**Cookers**   **599 526 071**   **EN**

Built-in ovens with „Avantgarde" Input Electronics

Data lines   Load lines

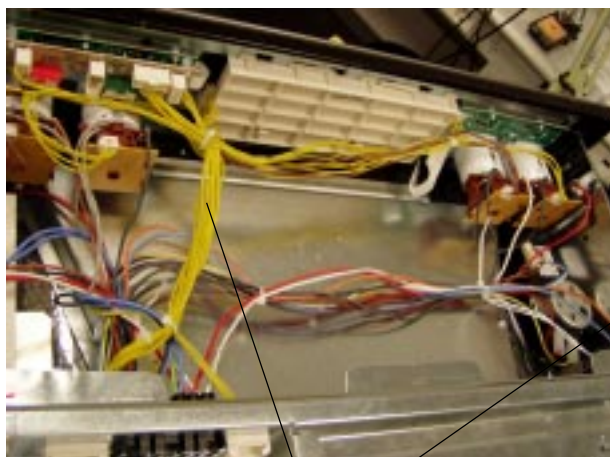
Problem: It is possible when commissioning an induction hob that the Avantgarde Oven Electronics automatically resets, whether the oven is in operation or not. It then reacts like a voltage cutoff and all settings (clock, language etc) should be adjusted again.

Cause: Perturbances on the data lines by parallel installation with load lines.

Remedy: Install data and load lines in isolated ways, refer to bundling photographs.
